THE CITY OF KEY WEST  
PLANNING BOARD  
Staff Report

Application: **Variance** - 1409 Albury Street (RE# 00024150-000000) – A request for a variance to the maximum allowed building coverage and the maximum allowed impervious surface in order to construct a pool and spa at a parcel located in the Historic Medium Density Residential (HMDR) zoning district pursuant to Sections 90-395, 122-600 (4) a., and 122-600 (4) b.

Site Plans submitted on 10/14/2020

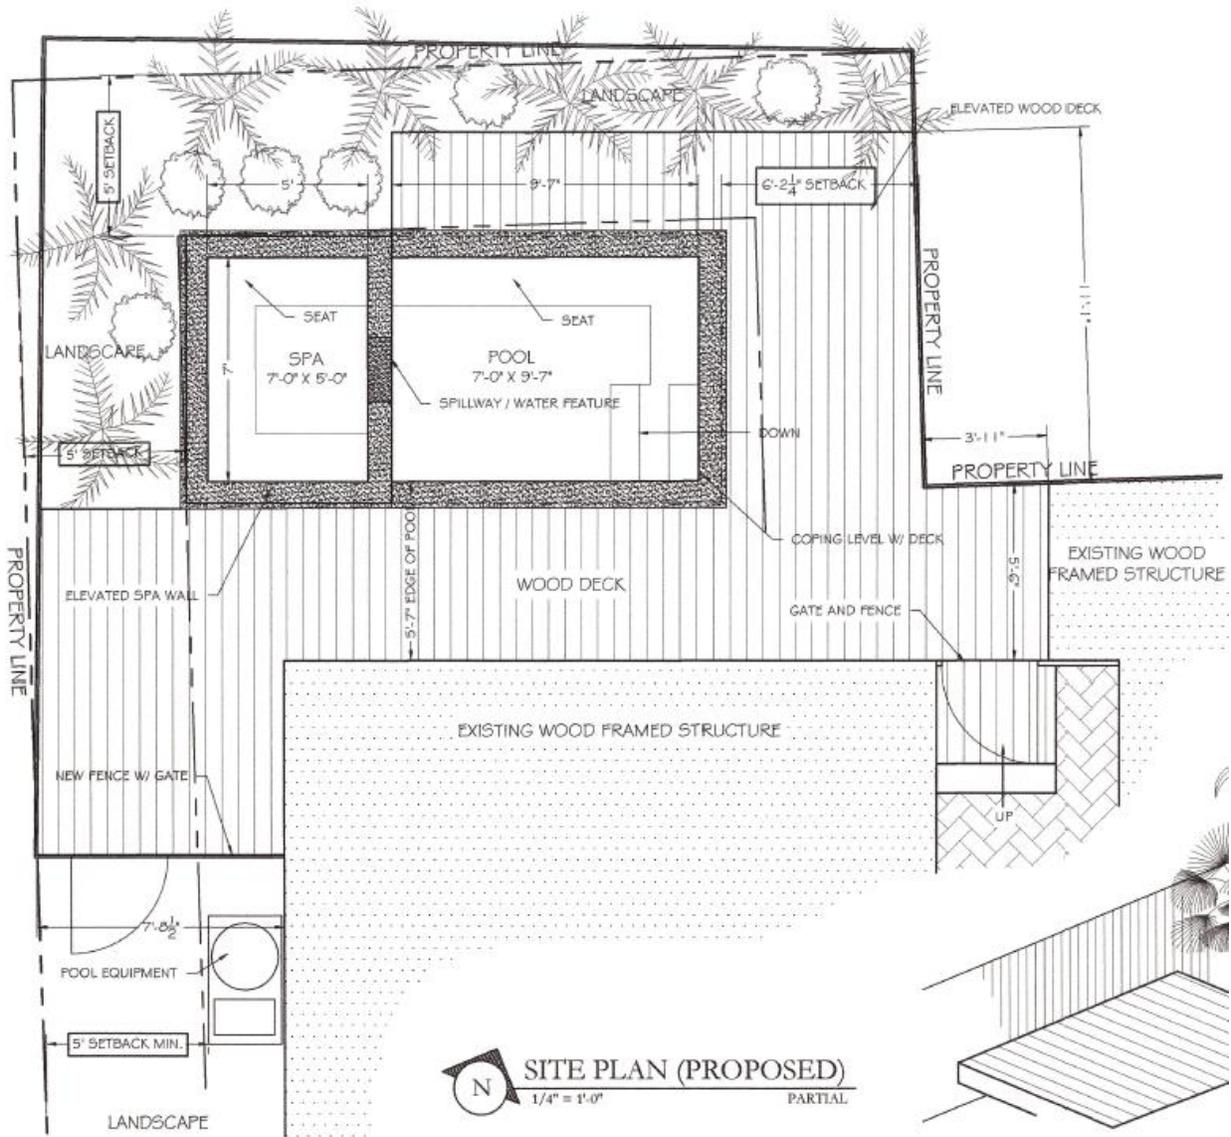
The applicant applied for a building permit to construct a pool, spa, and wood deck on 10/14/2020. A correction comment was issued to the applicant on 10/19/2020 requesting information regarding the building coverage, impervious surface, and lack of boundary survey. The permit reviewer, Daniel Sobczak, and the architect, Brian Olson, communicated regarding the building permit, the need for a variance, and mitigation factors for the project. The architect submitted revised plans for the building permit on 11/16/2020. The revised plans showed a significant decrease in building coverage and impervious surface and a significant increase in open space. These revised plans indicated the architect's willingness to collaborate with staff to minimize noncompliance.

The applicant has proposed the original plans submitted 10/14/2020 for this variance instead of the revised building permit plans that minimized noncompliance submitted 11/14/2020. The site table below details the current and proposed site data for the property. Four variances are proposed for this development.

This is not the minimum required variance that would make possible the reasonable use of the land, building and/or structure. The revised building plans show that it would be possible to reduce their overall variance request and still be able to construct the proposed pool, spa, and wood deck. The applicant also does not show any stormwater mitigation techniques such as swales, raingardens, etc. that could help mitigate the overages in impervious surface.

If the Planning Board chooses to approve the variance, the Planning Department recommends the Planning Board approve the revised site plans submitted on 11/14/2020 for Building Permit # 2020-2896 following conditions:

1. The proposed construction shall be consistent (except for conditions of approval listed below) with the plans signed, sealed, and dated 10/5/2020 by Brian Olson.
2. The owner incorporates a swale proportionate to the property’s impervious surface ratio over the code required maximum
3. Landscaping be planted in the rear and side of the property to baffle noise, improve privacy, and generally mitigate the effects of the pool and above-ground spa.
4. The variance approval be for the Revised Site Plans submitted on 11/14/2020.
